TOWN OF BAY HARBOR ISLANDS PLANNING AND ZONING BOARD

April 17, 2018

Subject: Site Development Plan Application – Revision #1
Atlantis of Bay Harbor – 28 DU Multi-Family Residential Complex
10281 West Bay Harbor Drive
Bay Harbor Islands Acct. No. MB2017-21
MMPA Acct. No. 01-0702-1049

Below are all of the changes since the PZ Board approved the plans on March 21st, 2017:

DRAWING TITLE
LEVEL 4 FLOOR PLAN
SCALE: - DATE: APRIL 3, 2018
SHEET NUMBER
A-104
P&Z REVISIONS

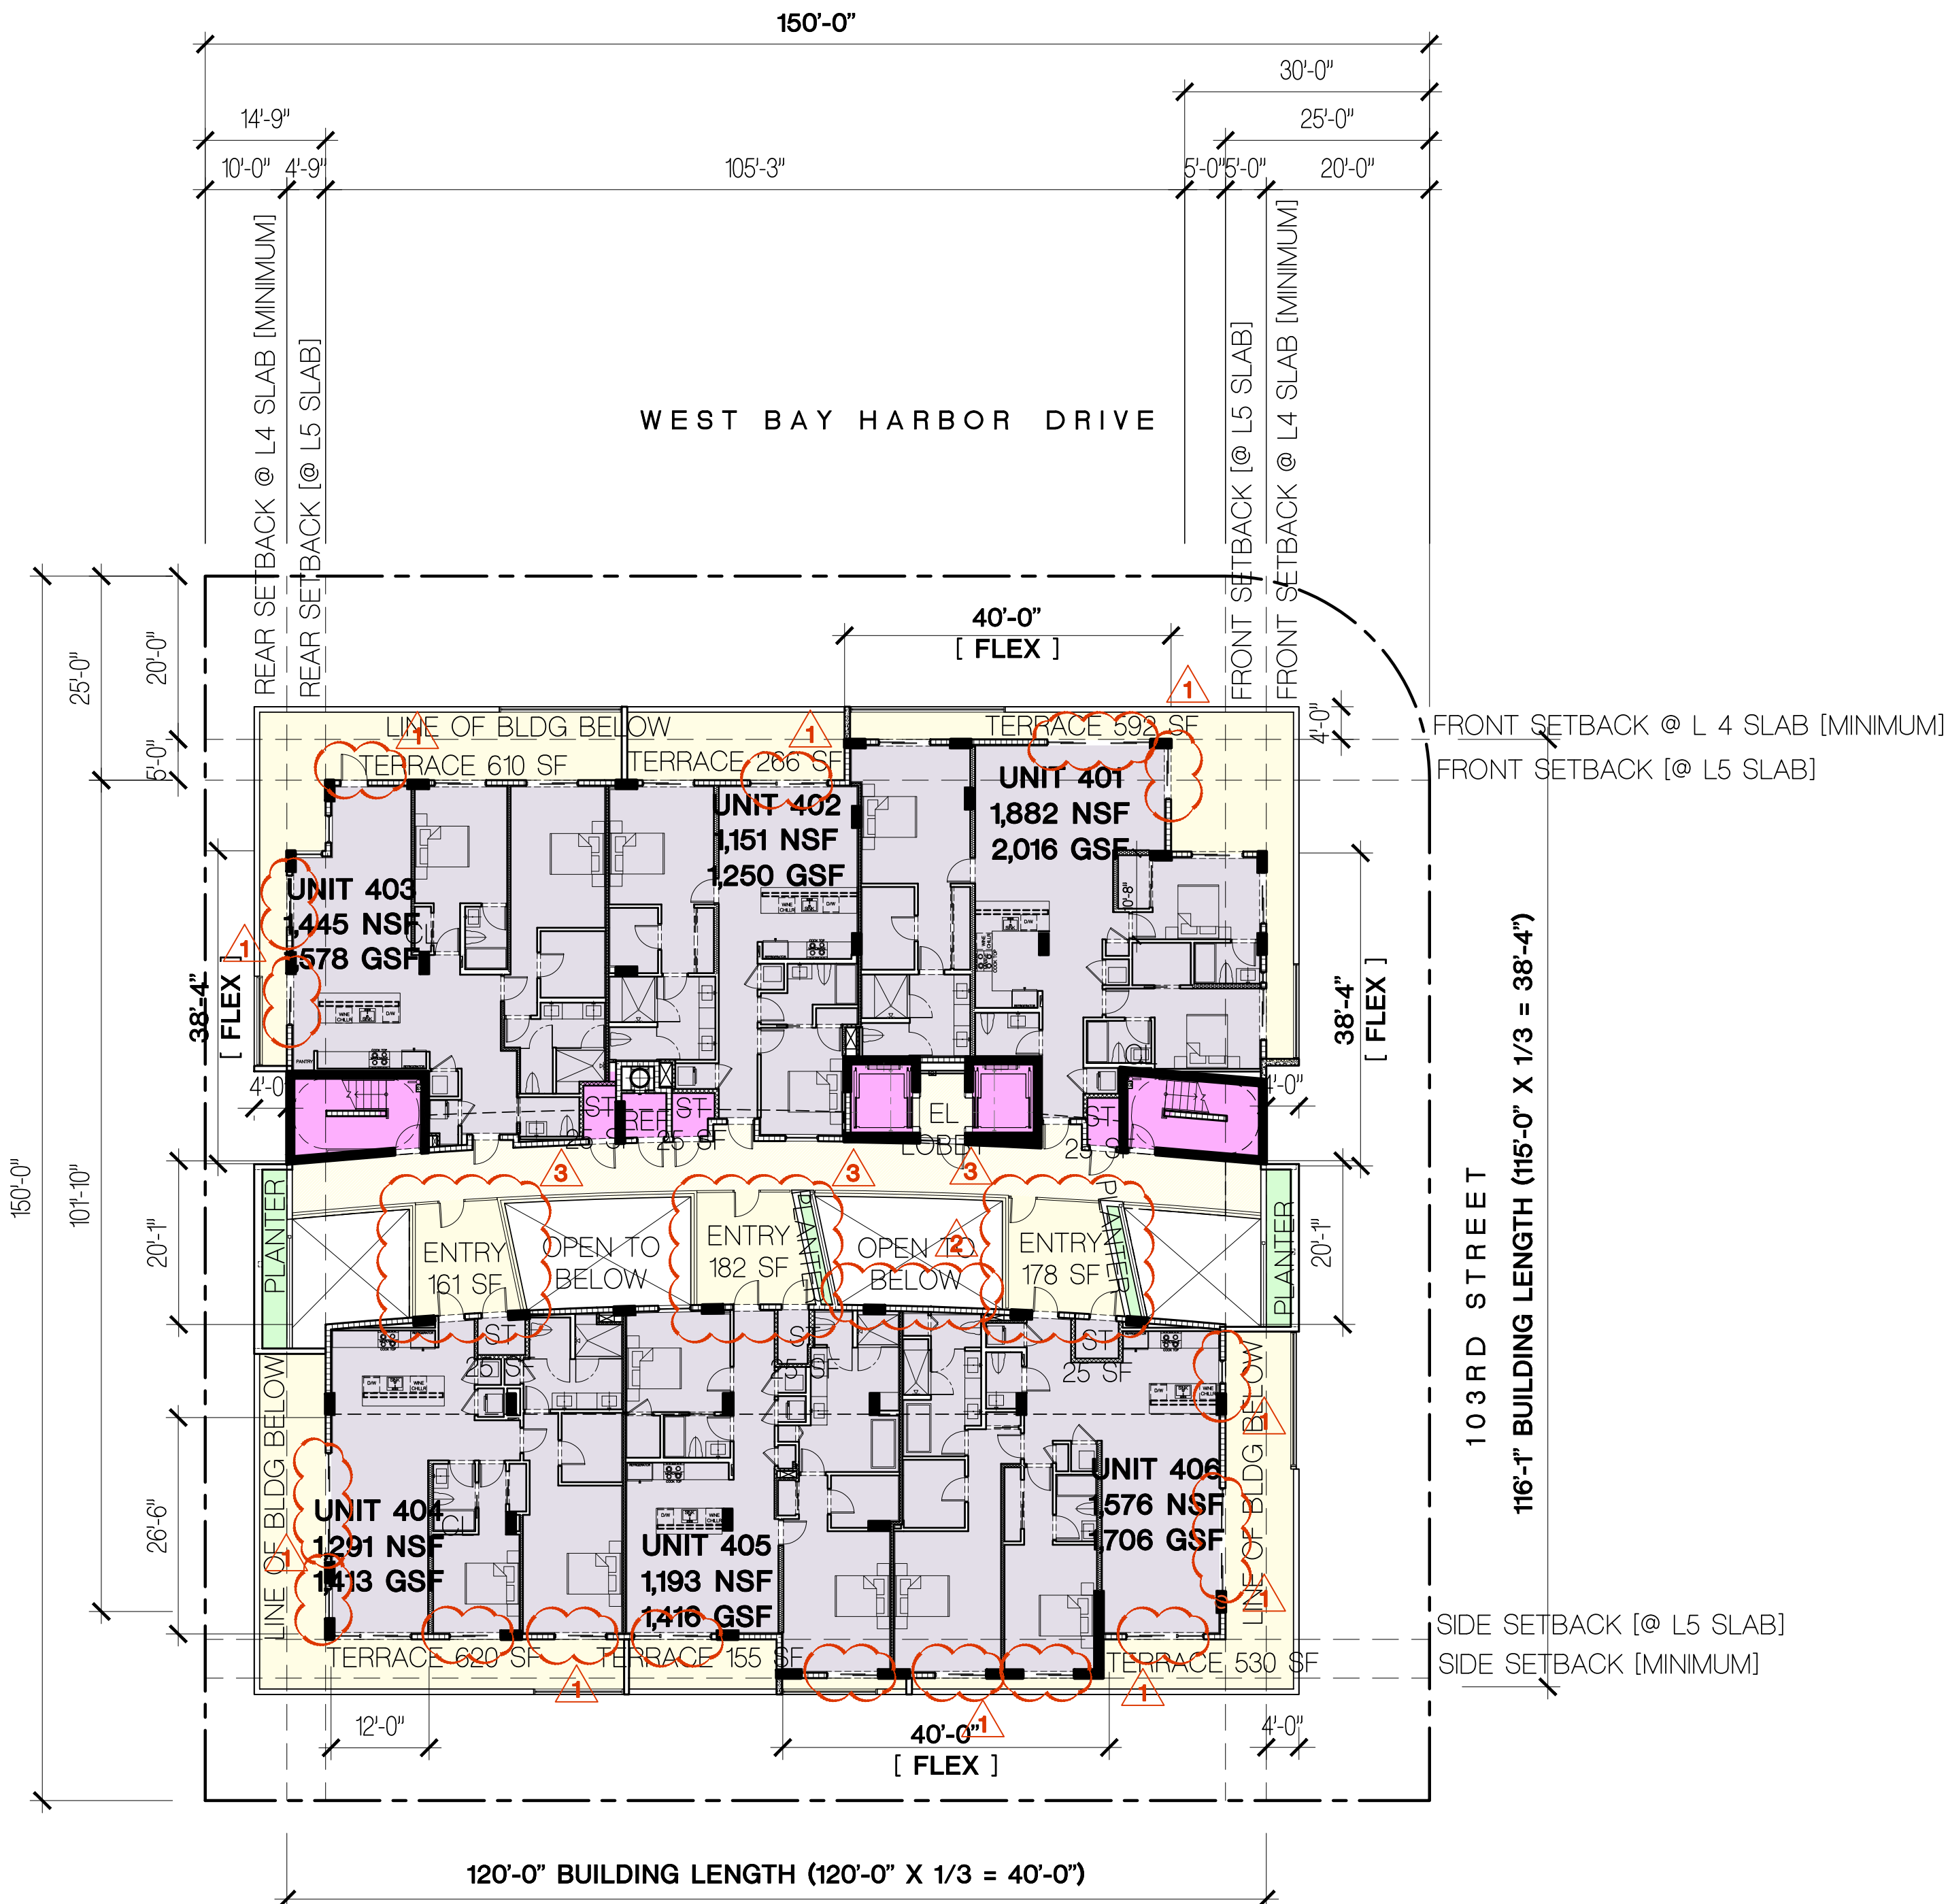
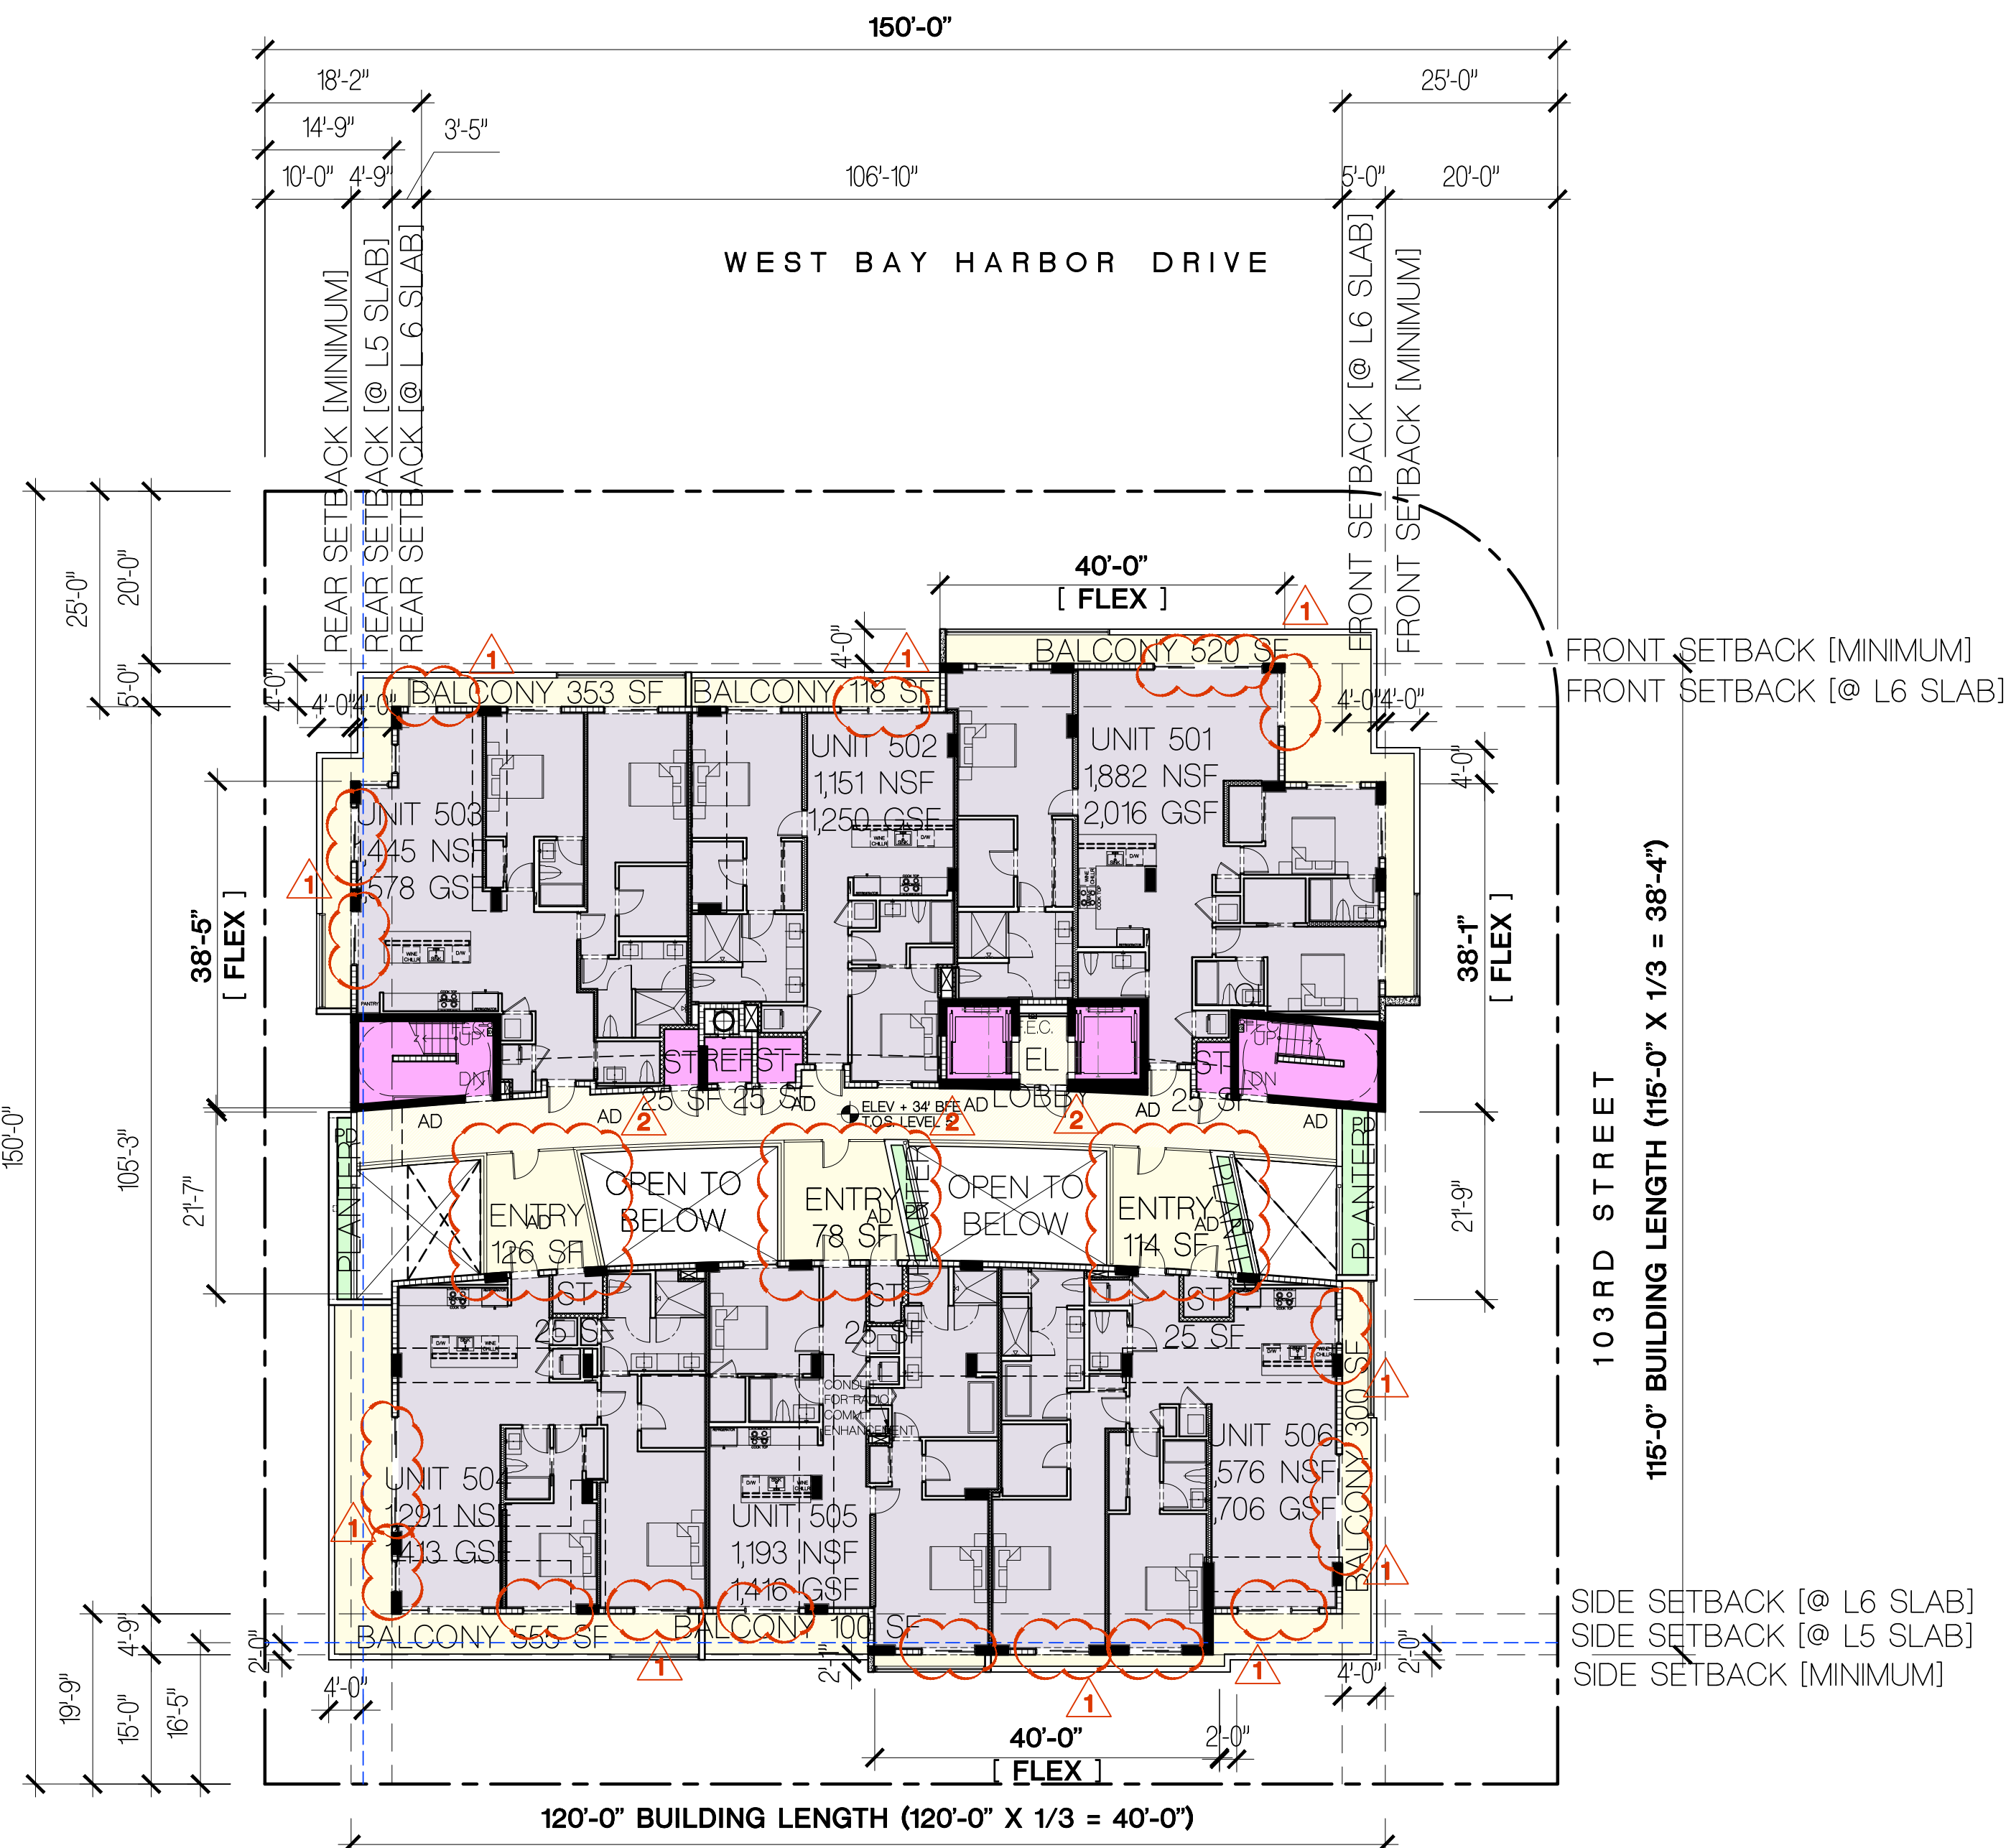
- NOTES:**
- 1 REDUCED GLAZING ALONG THE EXTERIOR PERIMETER
 - 2 ELIMINATED WATER FALL
 - 3 INCREASED THE AREA OF THE 3 PRIVATE ENTRY COURTS TO THE NORTH UNITS.
